ALERT SERVICE BULLETIN

505-21-21

MODEL AFFECTED: 505

SUBJECT: SUMP DRAIN FITTING GROMMET NAS557-18C,
INSTALLATION OF

FIGURE 1 – Fuel Filler Compartment (Zone 172)

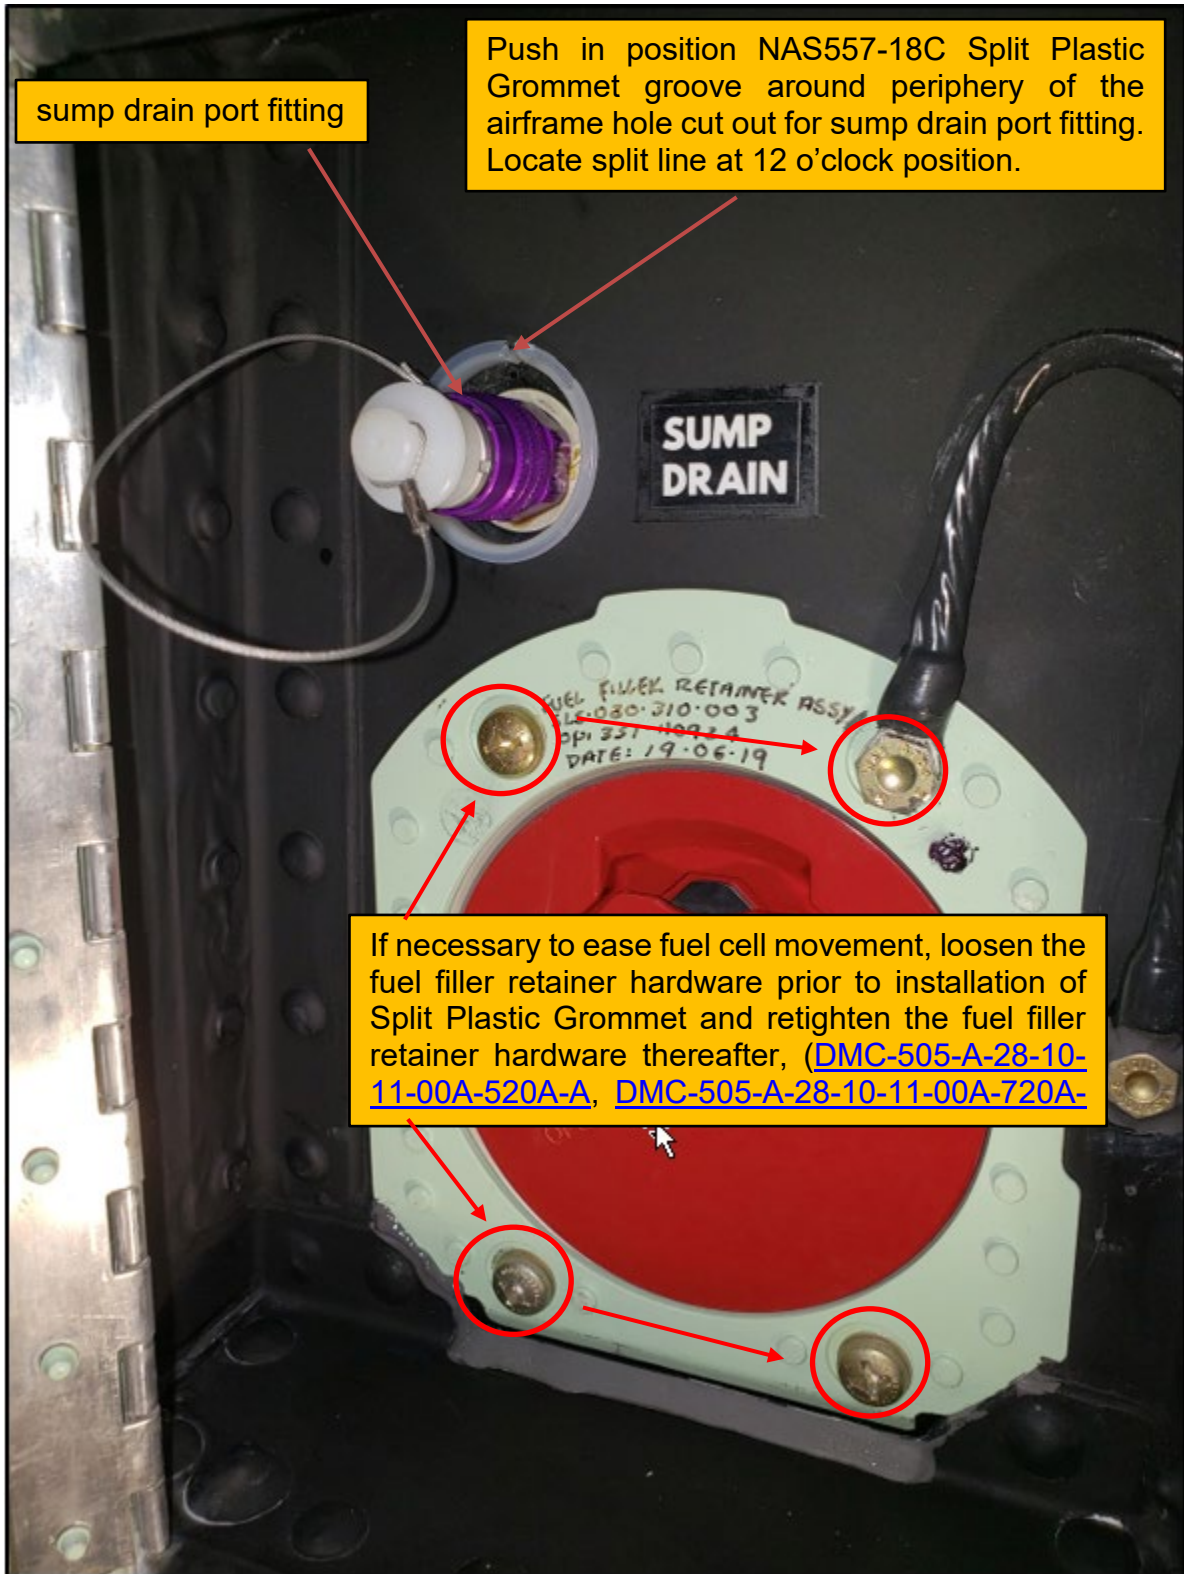
During airframe drop testing activity, it was discovered that by adding a frangible split plastic grommet interface to the airframe cutout where the sump drain fitting passes through provided an additional safeguard to the integrity of this installation following an impact.

This Alert Service Bulletin (ASB) provides instructions to install this split plastic grommet which is considered as a safety improvement.

1. Prepare the helicopter for maintenance.
2. Gain access to the fuel filler compartment (Zone 172), [DMC-505-A-06-30-00-00A-030A-A](#).
3. Locate sump drain port fitting (Figure 1).

If necessary to ease fuel cell movement, loosen the fuel filler retainer hardware prior to installation of Split Plastic Grommet and retighten the fuel filler retainer hardware thereafter, ([DMC-505-A-28-10-11-00A-520A-A](#), [DMC-505-A-28-10-11-00A-720A-A](#)) (Figure 1).

- a. Push in position NAS557-18C Split Plastic Grommet groove around periphery of the airframe hole cut out for sump drain port fitting (Figure 1).
 - (1) Locate split line at 12 o'clock position.
4. Close access to the fuel filler compartment (Zone 172), [DMC-505-A-06-30-00-00A-030A-A](#).
5. Make an entry in the helicopter logbook and historical service records indicating compliance with this Alert Service Bulletin.
